Final Supplemental Environmental Impact Report

Strauss Wind Energy Project

County EIR No. 18EIR-00000-0001 and State Clearinghouse No. 2018071002

8. Responses to Draft SEIR Comments

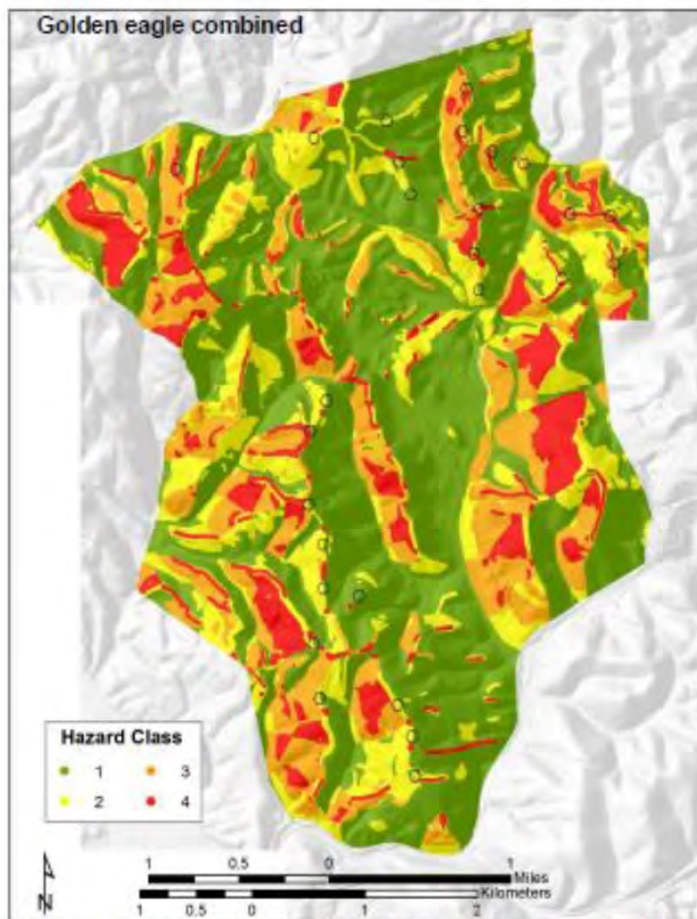
The figure shows that detailed data can be taken on the flight behavior of vulnerable species, such as the Golden Eagle. This data can be used to place WTGs in locations that will reduce avian mortality.

Figure A: Strauss Wind's Proposed Minor Modification to the Alternate Surface Transport Route

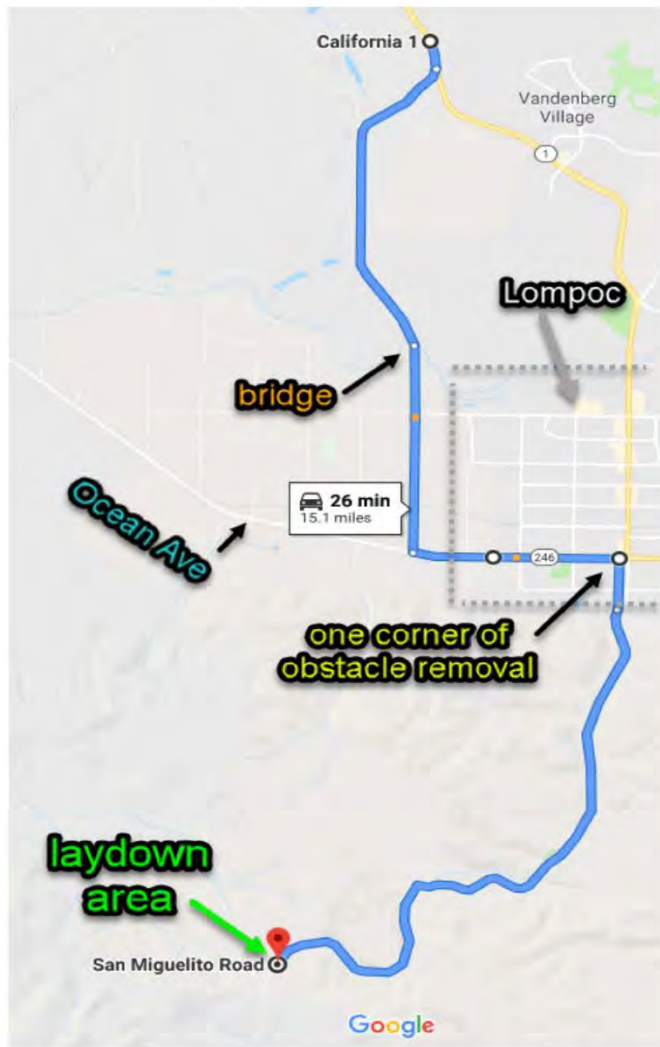
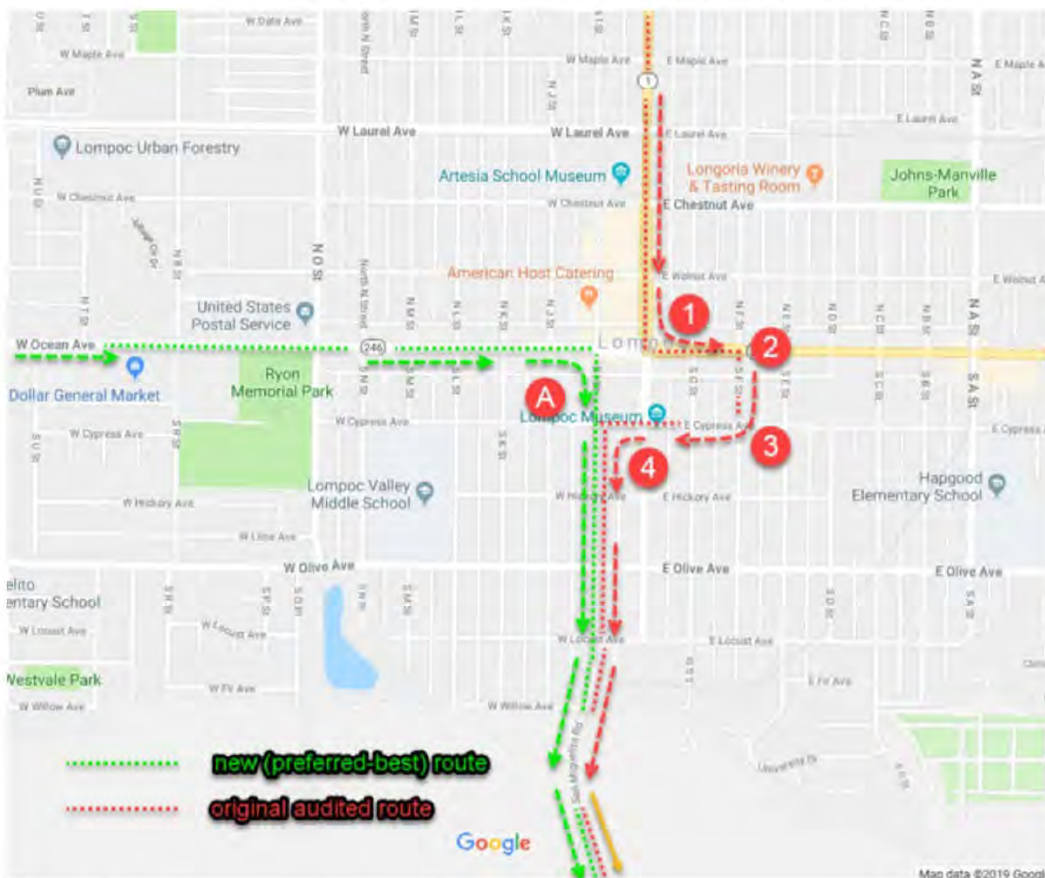
would then proceed east along W Ocean Avenue, entering the City of Lompoc and connecting with the portion of the proposed transport route, turning south on South F street, West on East Cypress Ave, and then south on South I Street. This Alternate Surface Transport Route is shown on Figure 5-3 of the Draft SEIR, which is depicted below for reference.

This Minor Modification to the Alternate Surface Transport Route would require the removal of three to four trees at the intersection of W Ocean Ave and S I Street. Further, one street light, two traffic lights and one traffic sign would have to be temporarily removed. This Minor Modification to the Alternate Surface Transport Route includes the following benefits:

- Reduction of approximately .44 miles of the Alternate Surface Transport Route.
- Avoidance of traffic disruptions at four intersections within the City of Lompoc (South H Street and West Ocean Ave., West Ocean Ave. and South F Street, South F Street and East Cypress Ave., and East Cypress Ave. and South I Street). Intersections 1 and 2 are among the busiest in the city, far busier than West Ocean and South I Street.

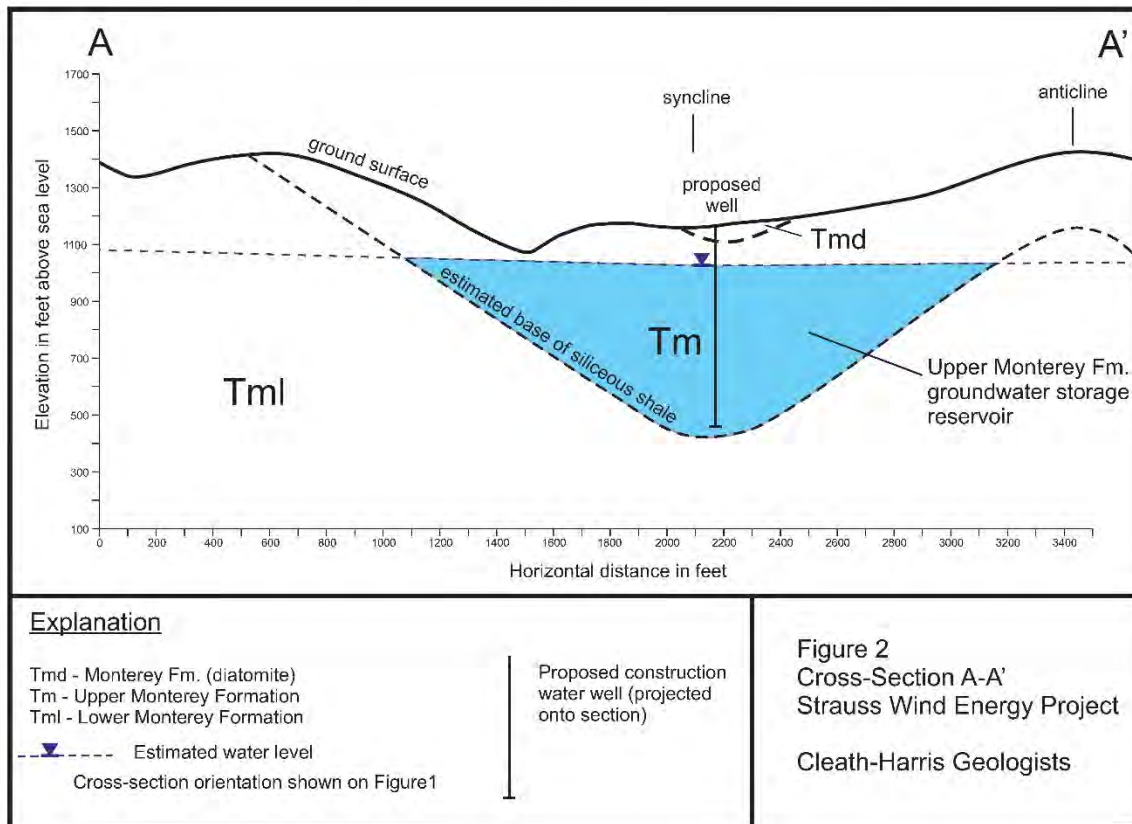
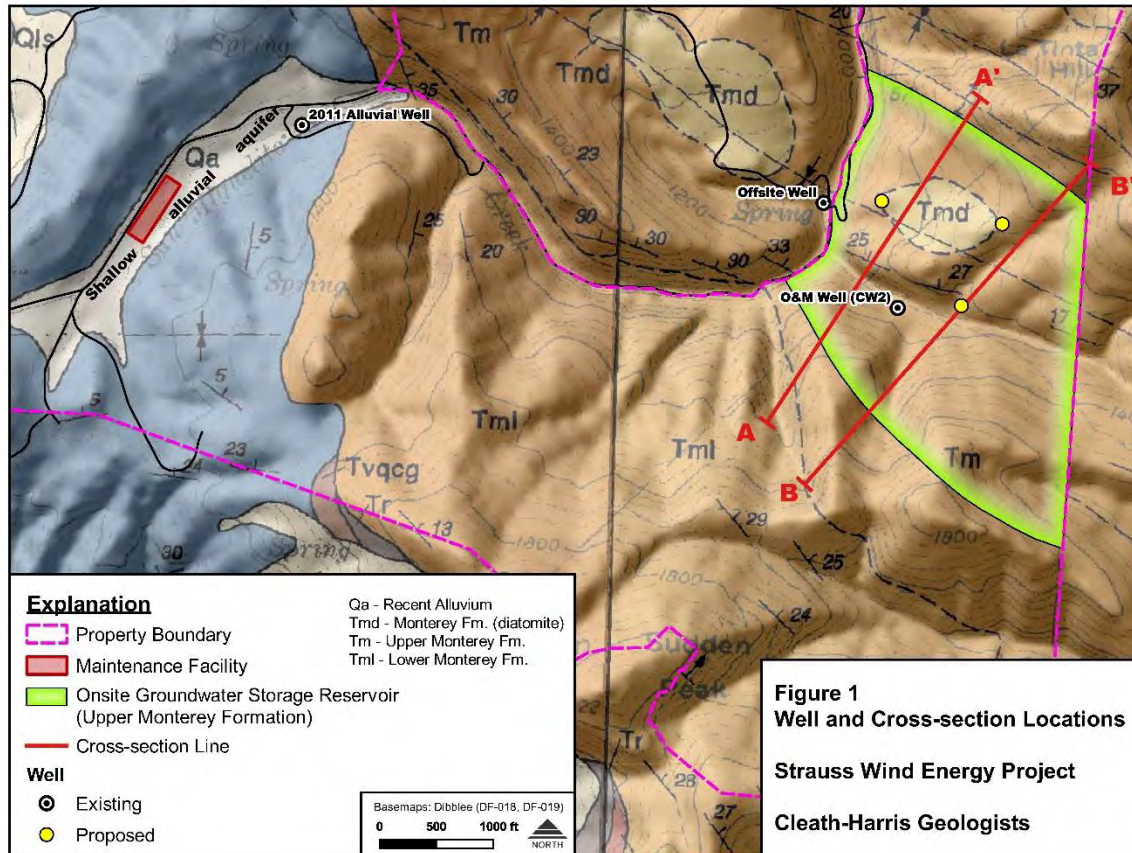
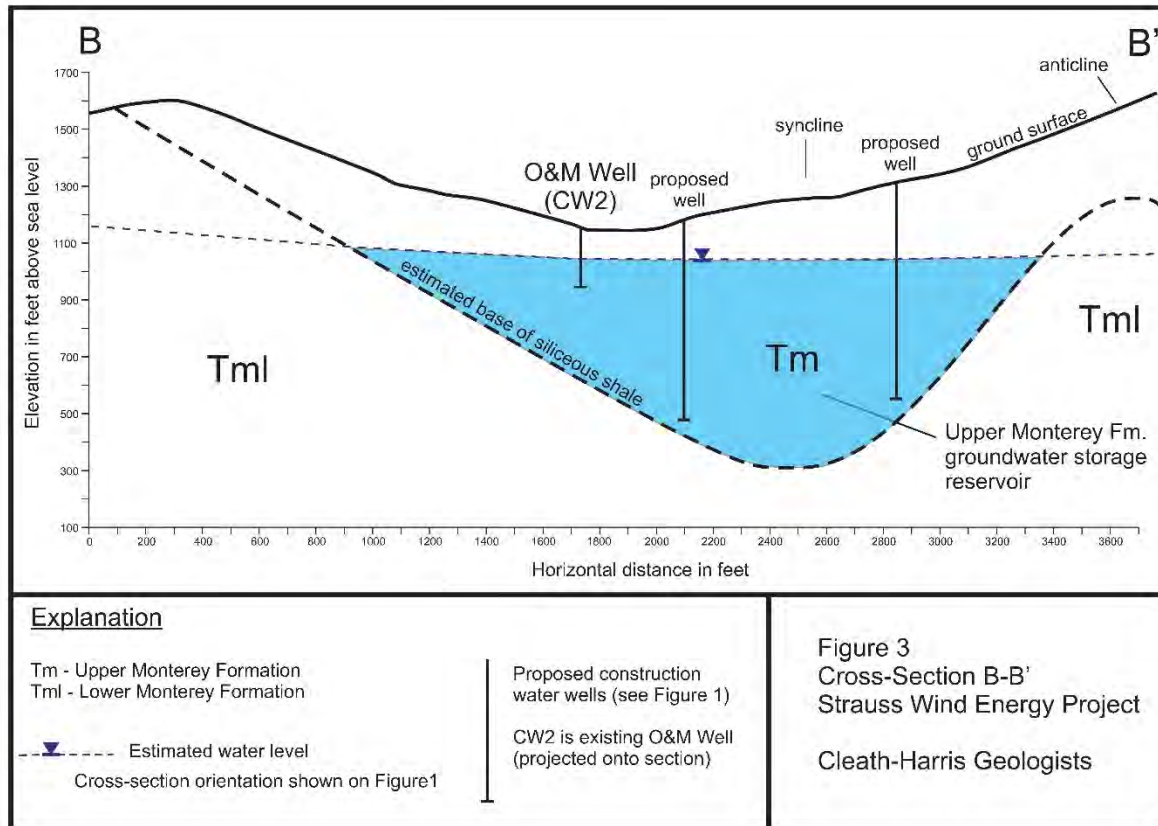
The proposed locations of future construction water wells in addition, or as alternative, to water supplied by the Lompoc Water Treatment Facility are shown in Figure 1. These wells would tap a groundwater reservoir within the siliceous shale of the upper Monterey Formation that is considerably larger than the shallow alluvial aquifer referenced in WAT-4. Geologic cross-sections through the main groundwater reservoir are shown in Figures 2 and 3. The approximate lateral extent of the reservoir on the property is shown in Figure 1. Based on the results of the O&M supply well completed in the upper Monterey Formation (CW2; Figure 1), up to three more supply wells are planned in order to provide the needed production capacity to support construction. Construction water quality should be similar to the approved O&M Supply well (DSEIR Appendix E-2).

There appears to be one active well located across San Miguelito Road from the planned SWEP construction water wells (Offsite well; Figure 1). This well may be impacted by construction water pumping. The proposed recommendations below would mitigate potential impacts to this well.

In order to provide an additional, or alternative, source of SWEP construction water, while protecting existing land uses, CHG recommends changing mitigation measure MM WAT-1 (Construction Water Source) to:

- a) Allow development and use of on-site wells for construction water in addition, or as an alternative, to off-site sources; and
- b) Require the Applicant to perform water supply monitoring at any nearby existing off-site wells, and to provide water of suitable quantity and quality, as needed, to replace any loss in production at the wells.
- c) The mitigation would take effect during construction and continue post-construction through such time as water levels in the groundwater reservoir have recovered.
